## SMYRNA MUNICIPAL PLANNING COMMISSION

### MEETING MINUTES FEBRUARY 1, 2024

1. Addition to Villages of Valley Green, Section IV  
Enon Springs Road W & Wildwood Drive  
Owner / Developer: JSD Holdings

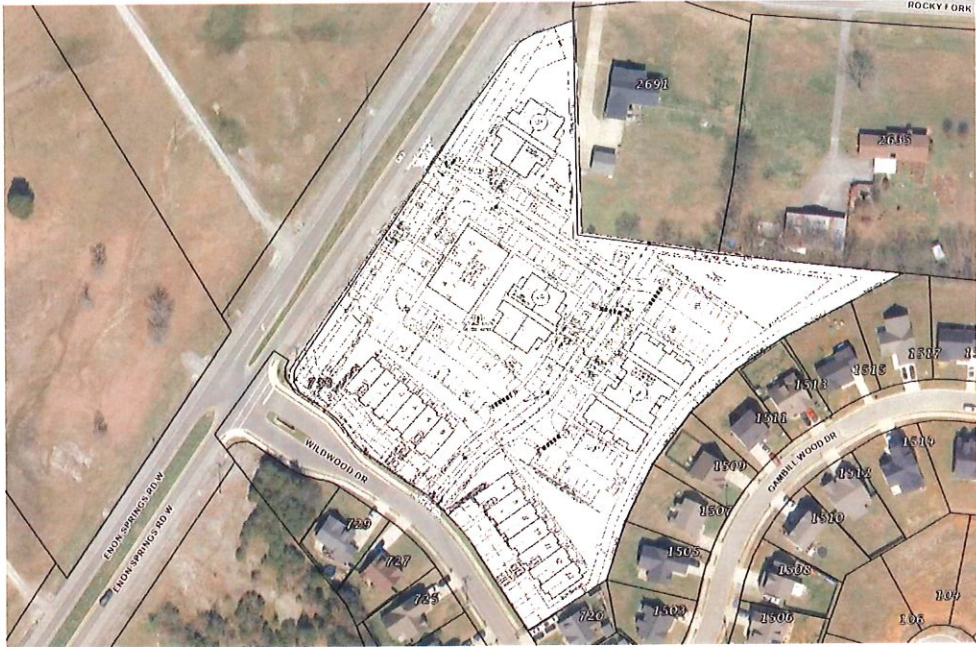
1. Utility plans are under review.
2. The required minimum fire flow will be 2,125 GPM at 20 PSI. This is based on the largest apartment building. The apartments are required to be sprinkled, and the other buildings may be required to be sprinkled depending on the construction type and available fire flow.

3. The approved subdivision plat for this lot showing the easement dedications must be recorded prior to issuance of any building permits for this site. Revise the plat to reflect the current plan.

4. Landscaping along Enon Springs Road, West will be required to comply with MTEMC overhead utility requirements. Substitute the dogwood and fringetrees along Enon Springs Road for a flame amur maple and add shrubs along Wildwood Drive.

5. Landscaping and storm structures cannot overlap. Please show one or the other relocated as needed.
6. The sidewalk to the playground area next to building 3 must have a crosswalk across the drive aisle to make it ADA accessible.

7. The new water main must be connected to the 12" main on the west side of Enon Springs Road, West. The roadway must be bored. A connection cannot be made to the east side of Enon Springs Road, West nor Wildwood Drive.

8. Please extend the sewer main to the Gambill property along the northern property line.
9. Please show one additional dumpster for the commercial building.

10. Provide a Type C landscape buffer between the multifamily uses and all of the surrounding single family uses. This should be extended along the property line adjacent to the townhomes to Wildwood Drive.

11. The parking calculations in the site data table are incorrect. Please adjust accordingly.
12. This site is required to meet ADA requirements. Please show handicapped parkings spaces spread throughout the development to serve all the apartment buildings as well as the commercial building. Handicapped people should not be required to cross drive aisles to reach their destination.

Motion by Mike Allen, seconded by Tim Slate to approve the site plan for Addition to Villages of Valley Green, Section IV with the above listed staff comments and the addition of one dumpster to be utilized by the commercial space.

1. 323 Lake Farm Road  
323 Lake Farm Road  
Owner / Developer: Jason R. Lloyd

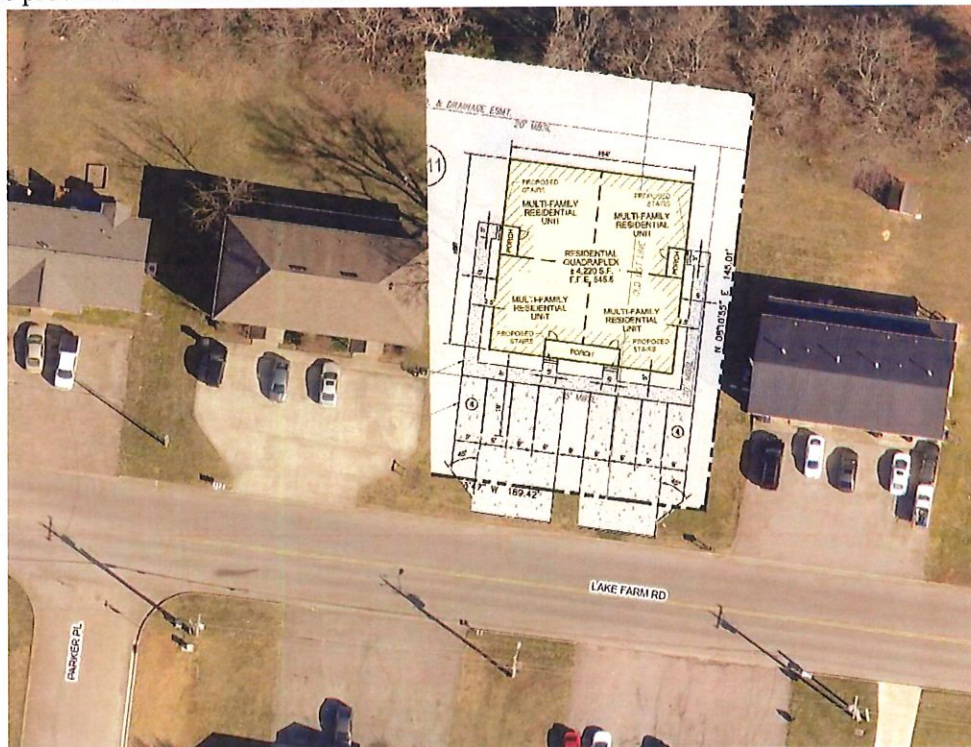
1. The site will be required to comply with ADA requirements due to the development being a quadruplex and is required to meet the commercial Building Code. One unit must be ADA compliant, a van accessible handicapped parking space is required, and a ramp is required.
2. The Zoning Ordinance requires 4 parking spaces per unit based on a quadruplex. Eight parking spaces are currently shown. An additional 8 spaces are required.
3. All water services lines must have a 2" gate valve by the utility main at the building to the left.
4. Show details for landscaping to be used in a data table.
5. Please update the FEMA map information to the current map.

**Staff Recommendation:** Staff recommends denial due to the parking area not meeting the Zoning Ordinance requirement for parking as well as the site not meeting ADA requirements.

2. Advance Auto Parts  
 1923 & 1929 Almaville Road  
 Owner / Developer: JMB Investment Company

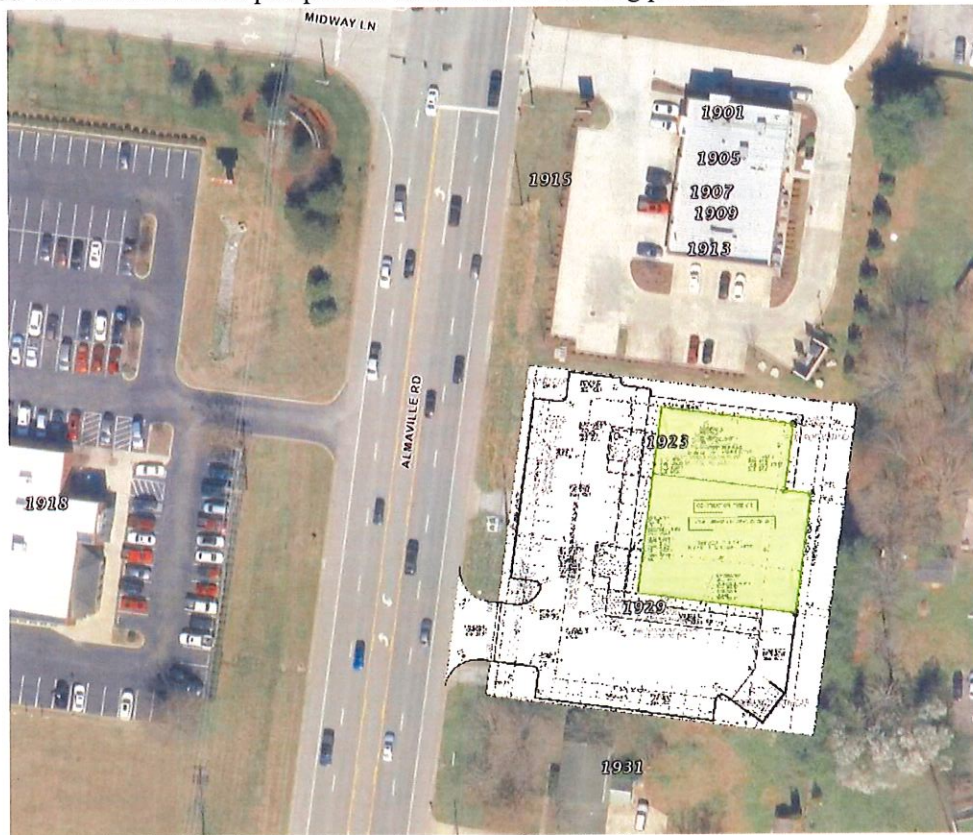
1. As existing, there are two lots of record. These lots will be required to be combined via a combination plat prior to issuance of a building permit. The sewer easement will also be required to be shown on the plat.

2. Coordinate landscaping requirements with MTEMC for the overhead utilities along Almaville Road. Substitute the sugar maple trees along Almaville Road with flame amur maple, ornamental trees or arborvitae. Staff would prefer flame amur maple to provide a street tree appearance.

3. Substitute the word "plastic" for "vinyl" fence along the rear property line.
4. TDOT approval for a driveway permit shall be provided prior to issuance of a building permit.

5. The required minimum fireflow is 2,250 GPM at 20 PSI for Type V-B construction. This can be reduced if the building has fire sprinklers installed, but the reduction varies depending on the type of sprinkler system. As indicated by CUD, there is not adequate fireflow to meet the minimum requirement even at the highest possible reduced amount of 1,000 GPM at 20 PSI.

6. Consolidated Utility District of Rutherford County (CUDRC) has an existing two (2) inch water main along the eastern side of Almaville Road to serve the property. Offsite water main improvements will likely be necessary and a connection to the existing twelve (12) inch water main along the western side of Almaville Road will be necessary to serve the site. Please refer to the CUD will serve letter issued 11/10/2023 and CUD comments issued 11/17/2023.

Motion by Amy Wise, seconded by Mike Allen to approve the Site Plan for Advance Auto Parts with the above listed staff comments to include the privacy fence must be constructed of vinyl.
